UNITED STATES PATENT AND TRADEMARK OFFICE

APPLICATION NO.	FILING DATE	FIRST NAMED INVENTOR	ATTORNEY DOCKET NO.	CONFIRMATION NO.
10/710,929	08/13/2004	Yihua Lu	MSCP0029USA	4928
27765	7590	07/22/2005	EXAMINER	
NORTH AMERICA INTERNATIONAL PATENT OFFICE (NAIPC) P.O. BOX 506 MERRIFIELD, VA 22116			VY, HUNG T	
			ART UNIT	PAPER NUMBER
			2821

Office Action Summary

DETAILED ACTION

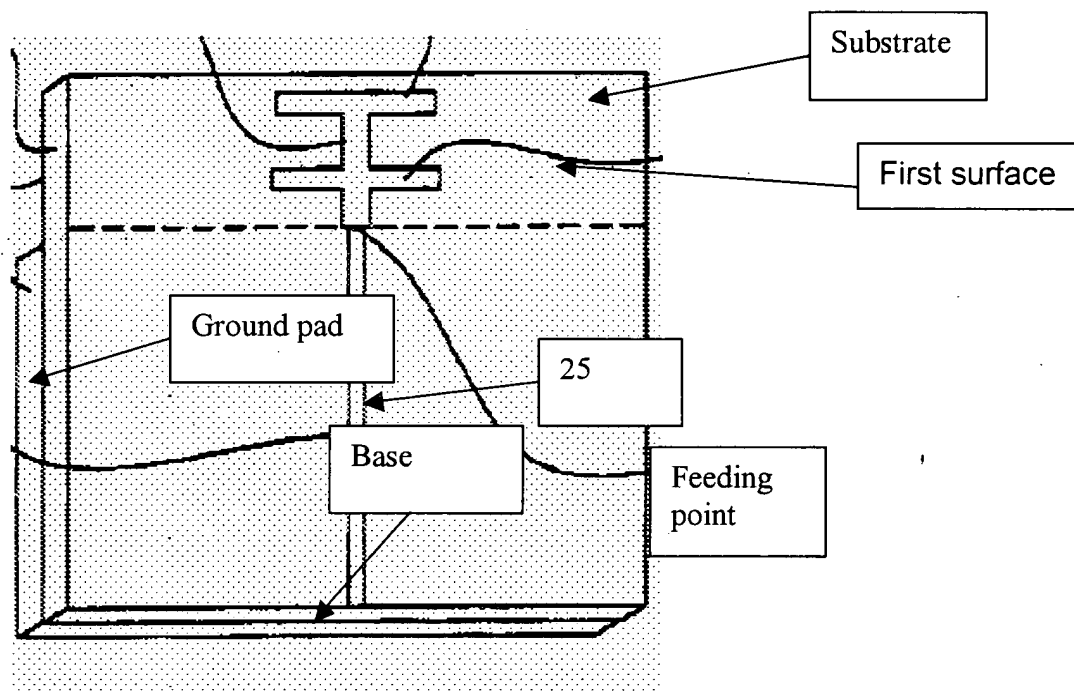
Claims 1-2, 5-8 and 10-13 are rejected under 35 U. S. C. § 102 (e) as being anticipated by admitted prior art (Admission) in Fig. 1.

Claim 1, Admission discloses a dual-band antenna, comprising a substrate 24 having a first surface and a second surface that is on the opposite side of the substrate 24 from the first surface, a transmission line 25 coupled to a feeding point for transmitting RF signals, an emitting unit having a first wire 21 and a second wire 22 that are both disposed on the first surface and the first wire 21 and the second wire 22 are crossed at the feeding point (See fig. above); and a ground pad 28 disposed on the

second surface of the substrate 24 (see fig. above), wherein the ground pad 24 comprises a base from the base extending toward the feeding point (See fig. above).

Claim 2, Admission discloses a transmission is a microstrip 25 (See fig. above).

Claim 5, Admission discloses the base of the ground pad is substantially rectangular (see fig. above).

Claims 6-8, Admission discloses an extension 28 disposed on the second surface and extending from the base toward a first edge of the substrate (see fig. above), the extension is adjacent to the emitting unit and the extension of the ground pad is substantially rectangular in shape (See fig. above).

Claims 10-11, it is inherent Admission disclose the first wire 21 decides the low operation frequency and second wire decides high operation frequency because with the same structure as the second wire 22 is shorter than first wire 21 from the feeding point.

Claims 12-13. Admission disclose the second wire 22 is extended upward from the feeding point and bent at some angle, being parallel to one side of the base and the first wire parallel to one side of the base (See fig. 1)
